Cumberland County Subdivision and Land Development Review Report

Municipality:	North Middleton	Surveyor/ Engineer:	Rettew	Owner/ Developer:	Paramount Portfolio LMS, Keytonne LLC
Plat Title:	Commercial Lots 106-107 for Keystone Arms				
Plat Status:	Preliminary/Final	Plat Type:	Subdivision and Land Development		
# of New Lots:	1	# of New Dwelling Units:	60	New Acreage Subdivided/Developed:	3.03
				Total Tract Acreage:	3.03
Zoning District:	Neighborhood Commercial	Proposed Land Use:	residential multi family		
Date Received:	8/17/2020	County Review:	9/2/2020	Reviewed by:	SH
				Checked by:	EG

PRELIMINARY/FINAL LAND DEVELOPMENT PLAN COMMERCIAL LOTS # 106 & 107 FOR KEYSTONE ARMS NORTH MIDDLETON TOWNSHIP, CUMBERLAND COUNTY, PENNSYLVANIA

LANDSCAPE & LIGHTING PLAN
 PRELIMINARY/FINAL LAND DEVELOPMENT PLAN
 COMMERCIAL LOTS 106 & 107
 FOR
KEYSTONE ARMS
 NORTH MIDDLETON TOWNSHIP CUMBERLAND COUNTY, PA

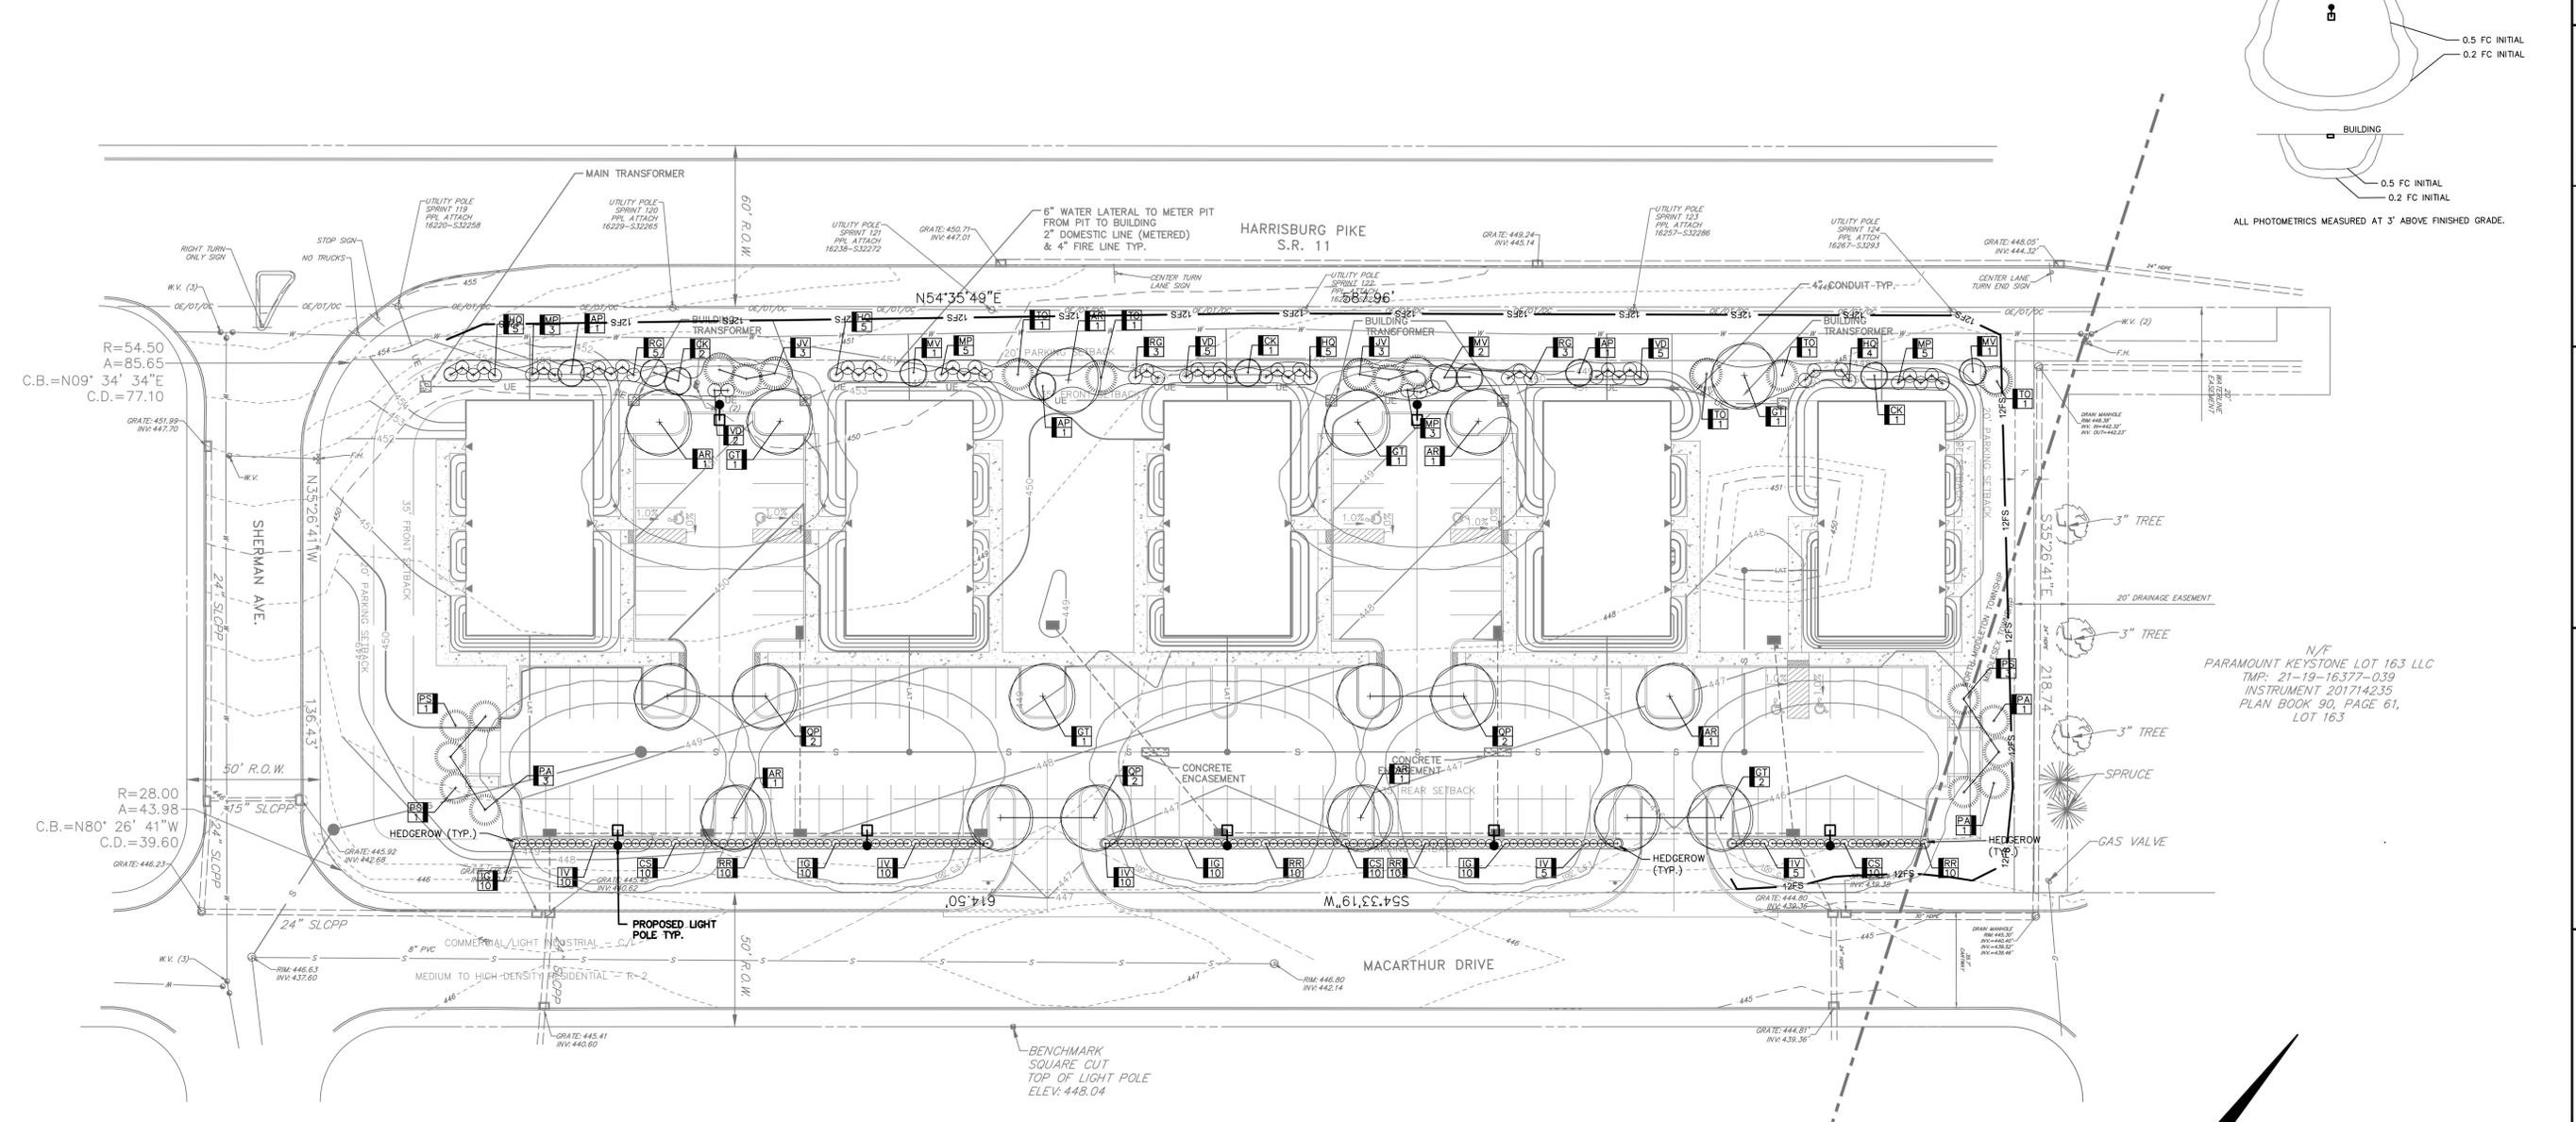
2. Sheet 9 indicates that Green Giant Arborvitae will be planted. American Arborvitae shall not be used to meet buffer yard requirements (Zoning 204-27.I.1.E). The Township should verify compliance with the Zoning Ordinance.

3. The Lighting Plan should include a 10' x 10' illuminance grid of footcandles to verify compliance (Zoning 204-37.B.9.D.2).
4. It appears that the plan is proposing a lot consolidation. The title of the plan should indicate a Subdivision and Land Development Plan (SLDO 180-24.B.2).
